J-2296-07

Re: Third Quarter Performance Report for 1996  
Avery Landing Recovery System

Hart Crowser is pleased to present the Third Quarter Performance Report for 1996 for the free product recovery system at the Avery Landing site. This letter report presents the third quarter groundwater elevation and product thickness measurements.

# Avery Landing Third Quarter Groundwater Flow Direction Map

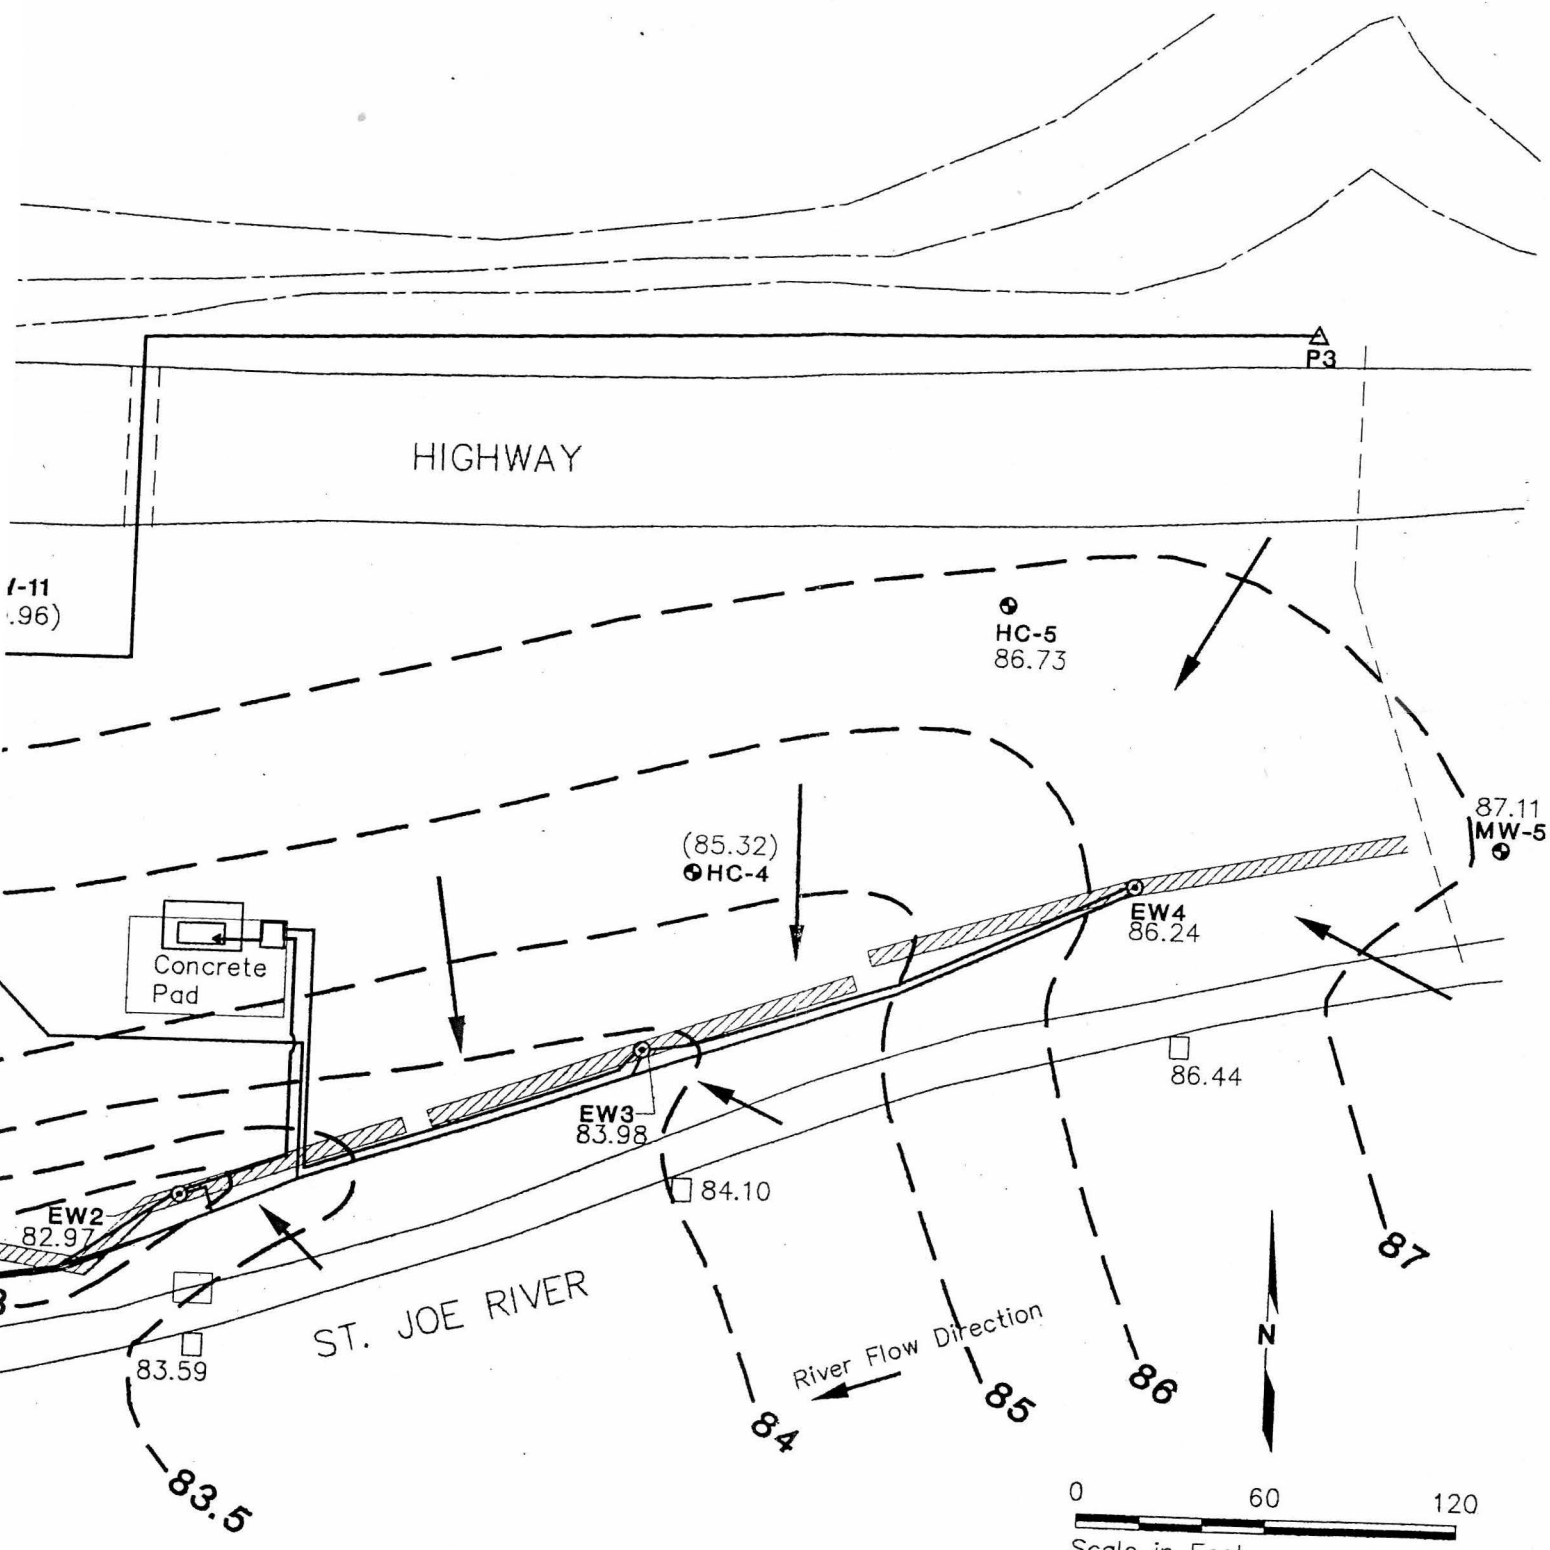
*I that you already recommended this last year?*
